OIL CONSERVATION DIVISION
1301 W. GRAND AVE
ARTESIA, NM 88210

Operator Klabzuba Oil Inc
 Well White #2
 Unit N Section 18 Township
 API # 30-005 - 10165

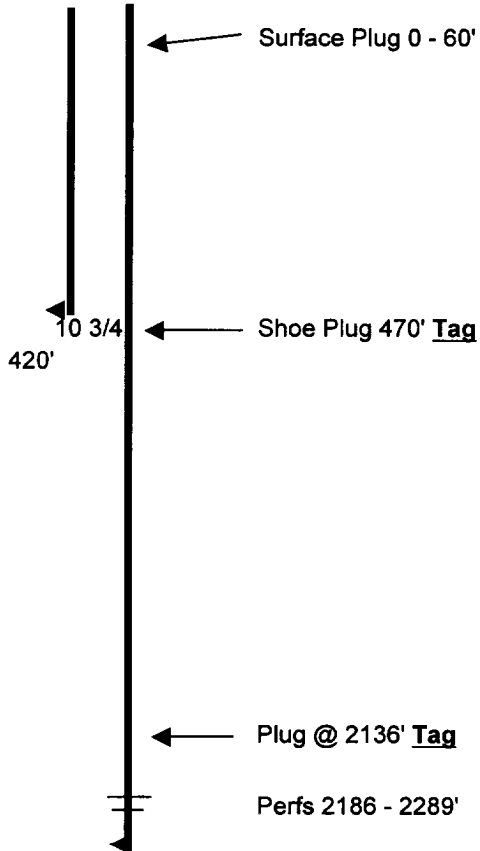
- * Contact OCD 24 hrs. prior to any work done.
- * Salt gel mud consisting of 10# brine with 25# of gel per barrel must be placed between each plug.
- * Install dry hole marker as per Rule 202.B.2
- * Plugs are to be set from point indicated up.
- * Plugs must not be less than 100' or 25 Sacks of cement, whichever is greater, unless specifically indicated.
- * Shoe and stub plugs will be 50' above and below shoe or stub and tagged.
- * Surface plug will be from 0' - 60'
- * Where plugs are required, cement must be placed inside and outside of **all** casing string(s) in the correct footage or sacks required, if **no cement exists**.
- * Plugs to be tagged will be indicated.
